# ADA Curb Ramp New Construction Inspection Form (Parallel)

NW Main

23885.56

NW Lenox

PARALLEL RAMP (PL)

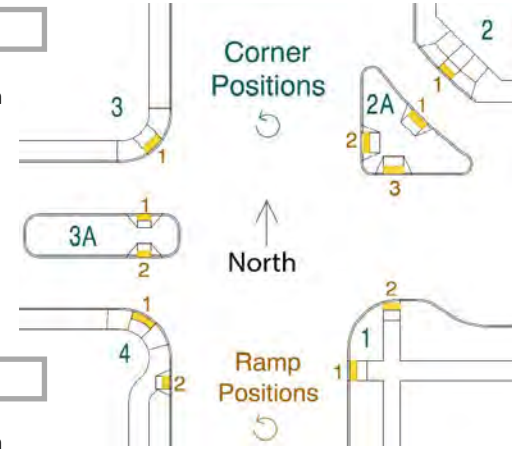
7.1  $\leq |5.0\%|$  ☒  $> |5.0\%|$  ☐

10.1  $\leq 8.3\%$  ☐  $> 8.3\%$  ☒

DWS IITD
